EC16-035

ITB17-042

INFINITI; DTC P0456 CAUSED BY EVAP LEAK AT VENT CONTROL VALVE O-RING

APPLIED VEHICLES: 2017-2018 QX30 (H15)
2014-2017 QX50 (J50)
2016-2017 QX60 and QX60 Hybrid (L50)

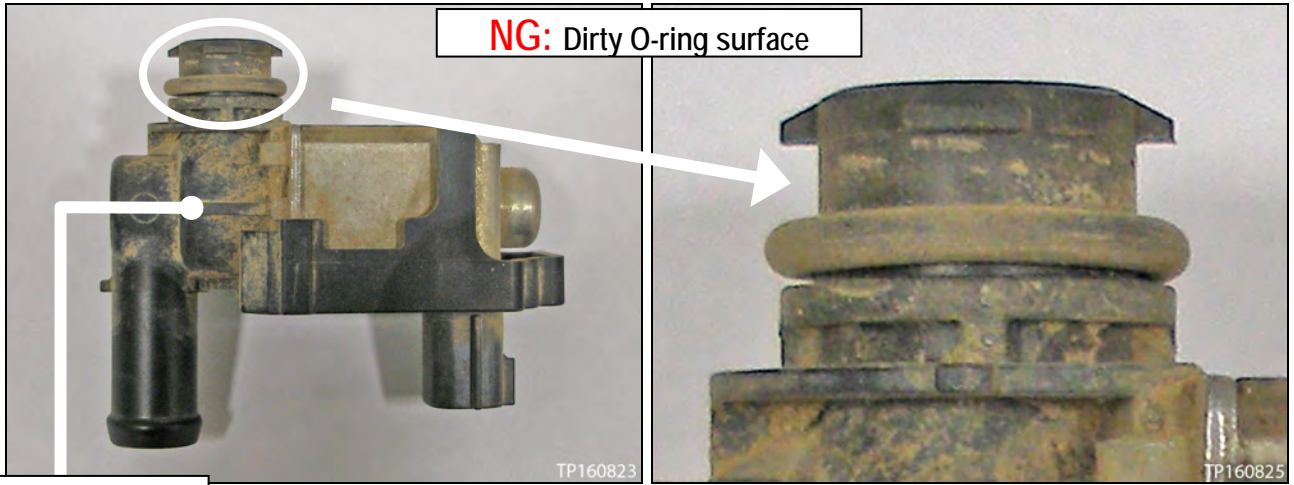
- Make sure the surfaces that the O-ring comes in contact with are clean.
- When installed, make sure the O-ring is not twisted or rolled over.
- Verify the repair is complete by checking for leaks with a “smoke” leak detection machine or CONSULT-III plus (C-III plus).
 - If a “smoke” leak detection machine is used, follow the manufacturer’s operating instructions.
 - If C-III plus is used:
 1. Confirm the fuel filler cap is secure.
 2. Connect Essential Tool J-42909 to the EVAP service port.
 3. Using Active Test, close the vent control valve.
 4. Apply pressure using J-42909 until the bar graph reaches about halfway.
 5. Monitor the bar graph for 10 minutes.

This surface must be clean all around
